DEVELOPMENT SERVICES

SITE PLAN REVIEW AND APPEARANCE BOARD

7th Avenue Banyan

Meeting	File No.	Application Type
January 25, 2023	2022-092-SPF-SPR-CL5	Class V Site Plan with Waiver
Applicant / Property Owner		Authorized Agent
West Atlantic Development Company, LLC		John W. Szerdi, LEED AP of Living Designs Group Florida Architects, Inc.

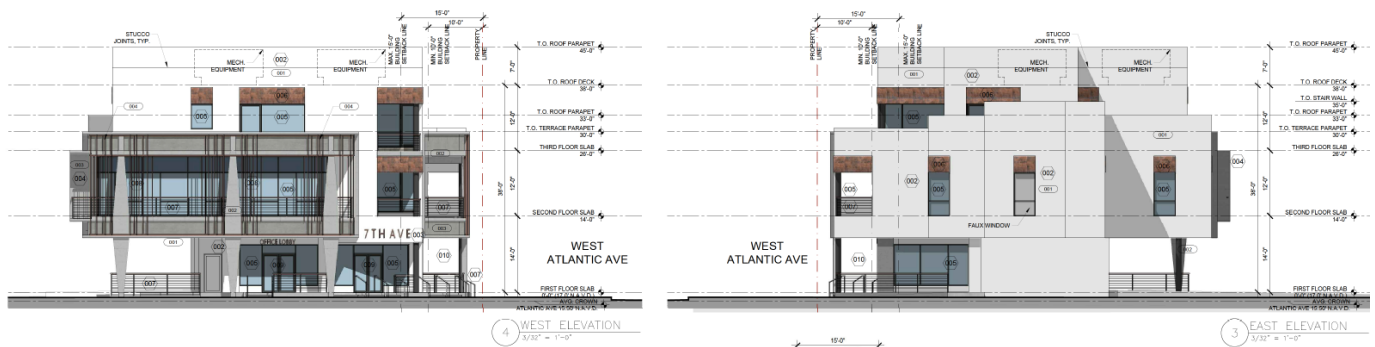
Pursuant to **LDR Section 4.4.13(6)(c)**, the maximum height of a parapet wall shall be six feet or sufficient height to screen all roof mounted equipment, whichever is greater. The parapet above the third floor is seven feet in height, necessary to screen the rooftop mechanical equipment. The blank treatment of the parapet, however, is without a banded detail to terminate the top and solidify the building on the ground, while breaking up the height of the parapet. The Board should consider if this additional detail, which is not inconsistent with the architectural style, should be added.
